**PLANNING COMMISSION MEETING
MUNICIPAL CENTER COUNCIL CHAMBERS
Tuesday, August 1, 2017**

4. Goodwin Farms Planned Unit Development (PUD)

Development Case Number:	17-729
Case Name:	Goodwin Farms PUD
Location:	North side of Winchester Rd., approx. 1,000 feet east of Crestwyn Drive
Owner/Developer Name:	Regency Homebuilders
Applicant/Representative:	Cindy Reaves w/ SR Consulting, Inc. and Paul Ryan w/ Regency Homebuilders (Agent)
Zoning District:	“R” Low-Density Residential

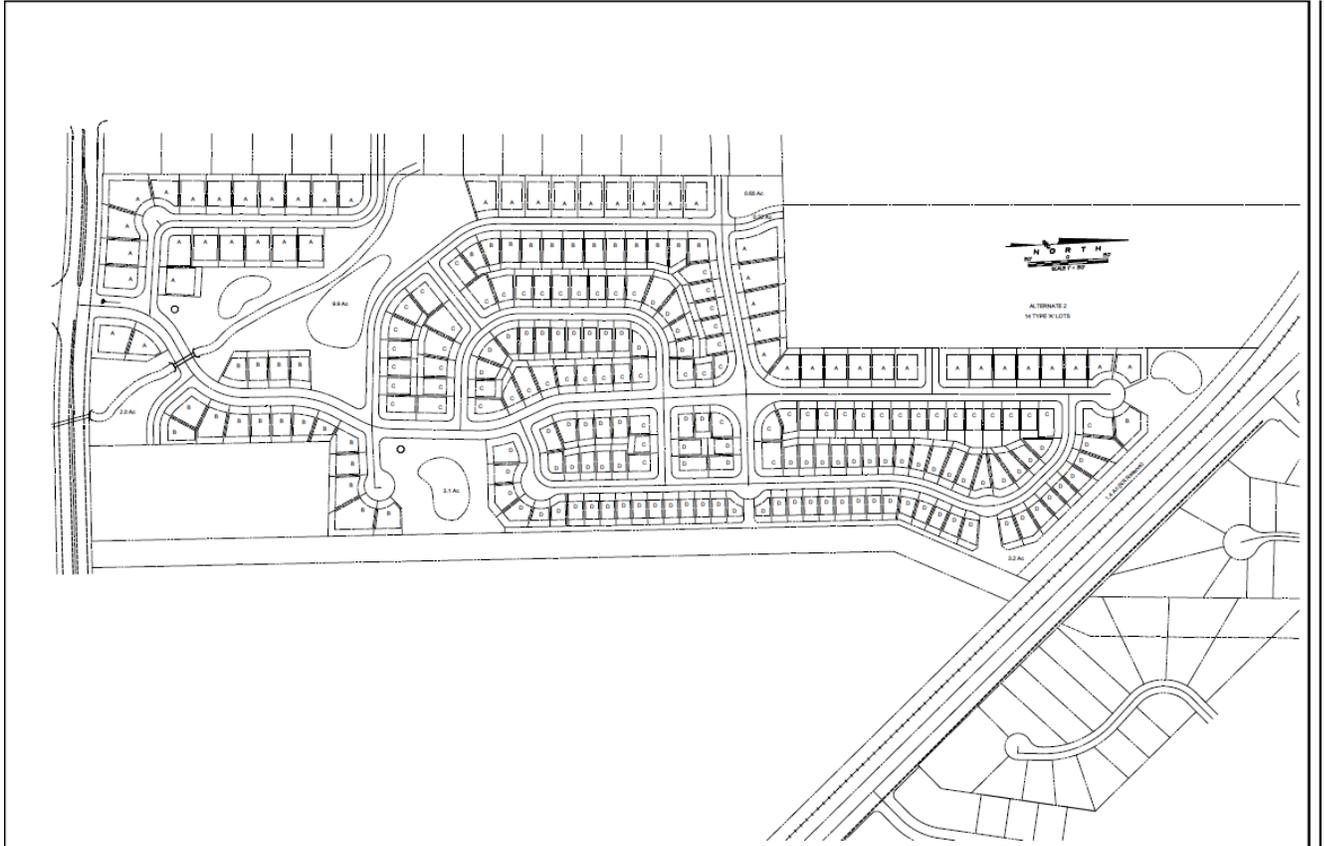
Could you ask Bob for the dimension from my southeast property line to the beginning of the 50' ROW for the stub street?

Attached is a revised plan showing the second stub street. Bob Sweeney thinks all of the lots along you property line can be 90' lots.

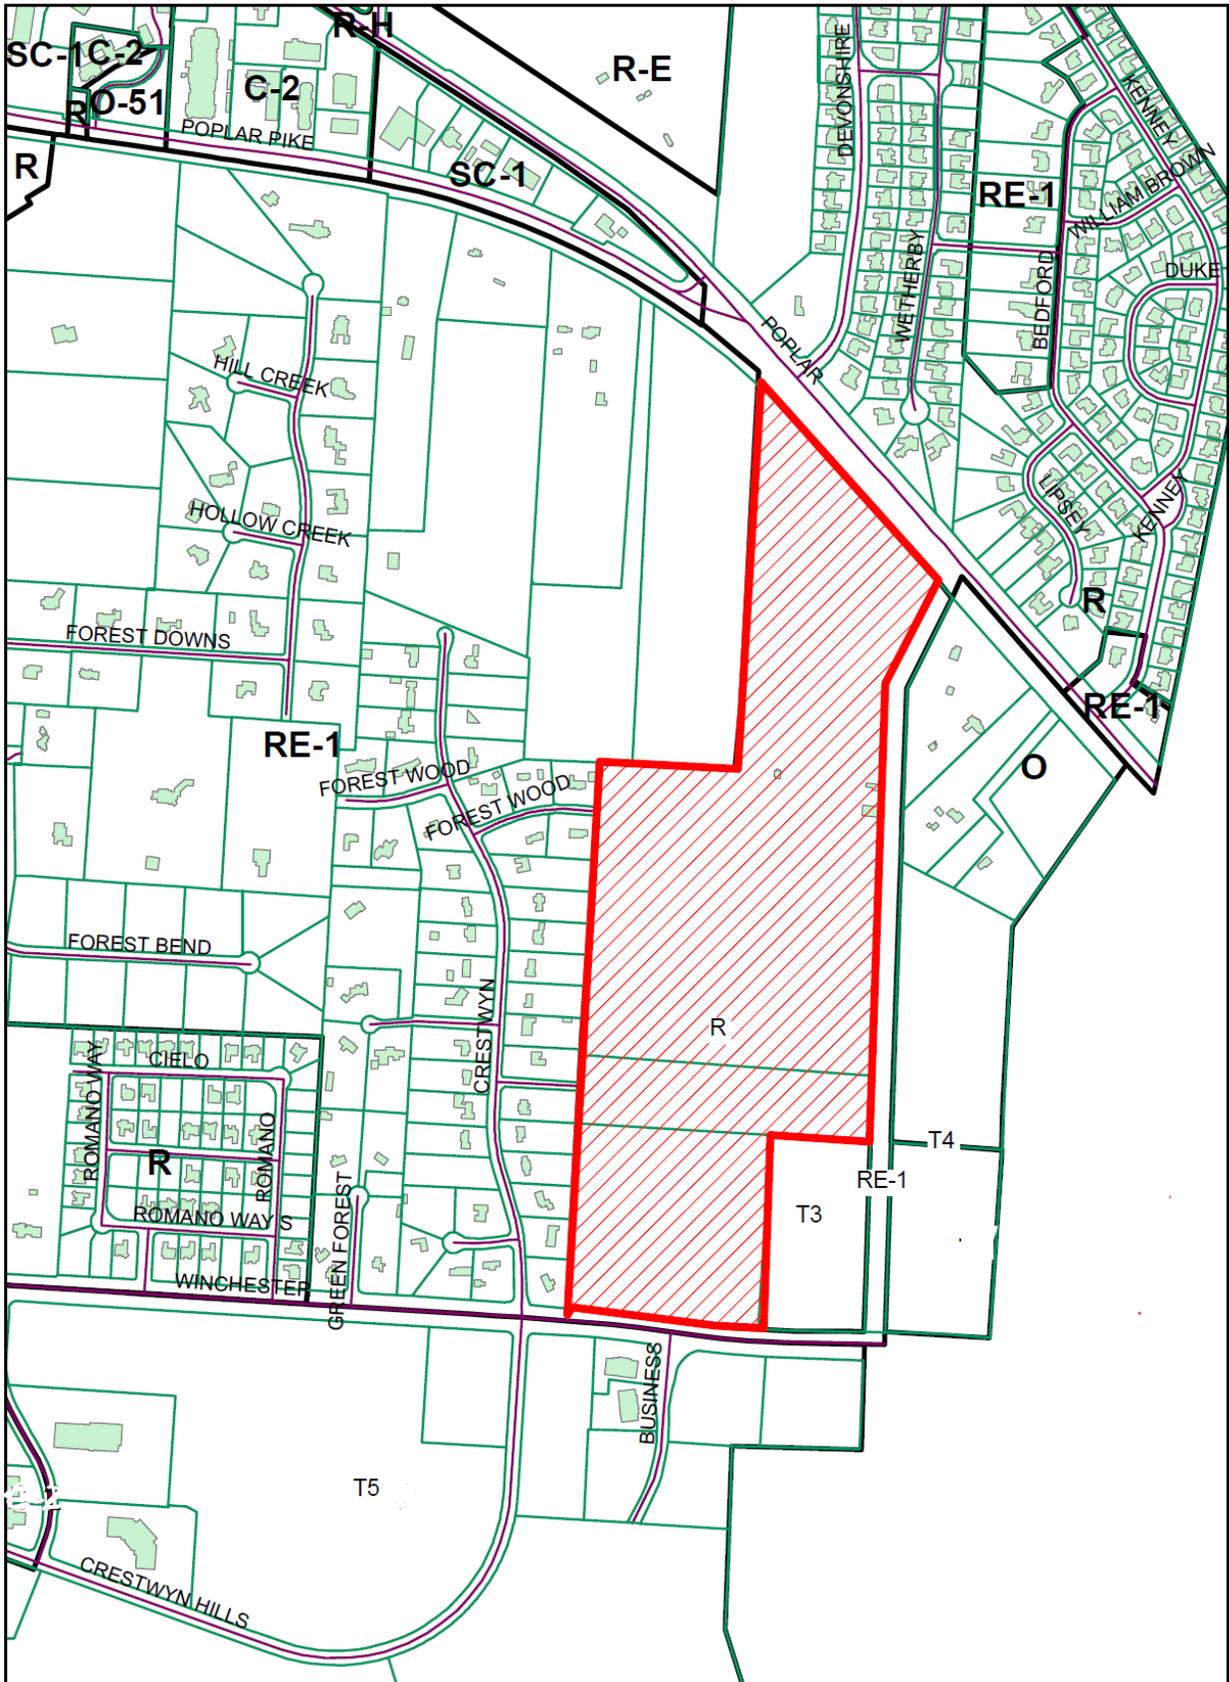
The developers have done an excellent job of reducing the traffic flow into Green knoll and I would like to see a similar effect at Forestwood. I have attached a drawing that shows two possibilities to greatly reduce the traffic flow from this subdivision at Forestwood.
